MARION S. KELLY ESTATES SUBDIVISION, **RESUBDIVISION OF**

APPLICATION NUMBER 11 DATE January 4, 2007
APPLICANT Marion S. Kelly Estates Subdivision, Resubdivision of
REQUEST Subdivision

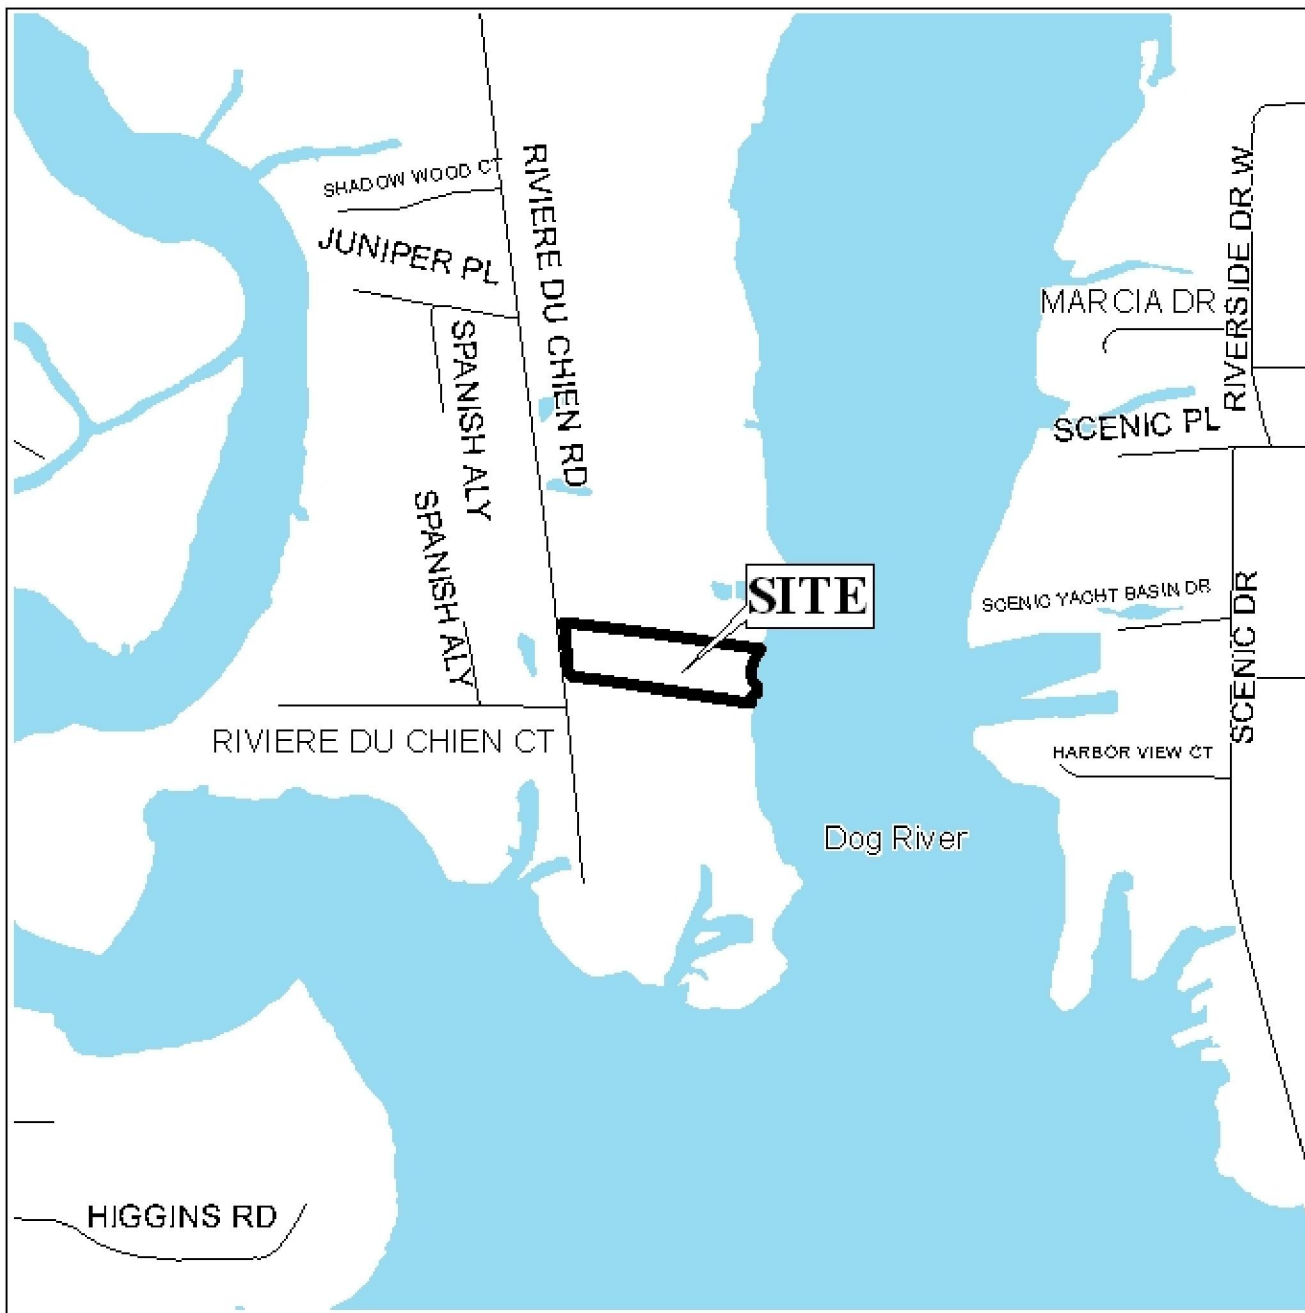
Engineering Comments: Show minimum finished floor elevation on each lot. Must comply with all storm water and flood control ordinances. Any work performed in the right of way will require a right of way permit.

Traffic Engineering Comments: Driveway number, size, location, and design to be approved by Traffic Engineering and conform to AASHTO standards.

Urban Forestry Comments: Property to be developed in compliance with state and local laws that pertain to tree preservation and protection on both city and private properties (State Act 61-929 and City Code Chapters 57 and 64).

The proposed lots will exceed the depth to width ratio recommended by Section V.D.3. of the Subdivision Regulations, however, the subdivision will remedy an existing condition of lots fronting onto a private right-of-way that lacks adequate width. It should also be pointed out that lots exceeding the recommended depth to width ratio are common along Dog River, thus a waiver of Section V.D.3. may be appropriate.

The site fronts onto Riviere du Chien Road, a minor street with adequate right-of-way. While Riviere du Chien Road is a minor street, access management is a concern. Each lot should be limited to one curb-cut onto Riviere du Chien Road, with the size, design and location to be approved by Traffic Engineering and conform to AASHTO standards.

The site is bounded to the East by Dog River, and wetlands and floodplains associated with the waterway may occur on a portion of the site. The presence of wetlands and floodplains indicate that the area may be environmentally sensitive; therefore, the approval of all applicable federal, state and local agencies would be required prior to the issuance of any permits or land disturbance activities.

With a waiver of Section V.D.3., the plat is recommended for Tentative Approval, subject to the following conditions: 1) placement of a note on the plat stating that each lot is limited to one curb-cut each onto Riviere du Chien Road, with the size, design and location to be approved by Traffic Engineering, and comply with AASHTO standards; 2) labeling of each lot with its size in square feet, or provision of a table on the plat with the same information; 3) placement of a note on the plat stating that approval of all applicable federal, state and local agencies is required prior to the issuance of any permits or land disturbance activities; 4) compliance with Engineering comments (*Show minimum finished floor elevation on each lot. Must comply with all storm water and flood control ordinances. Any work performed in the right of way will require a right of way permit.*); and 5) full compliance with all other municipal codes and ordinances.
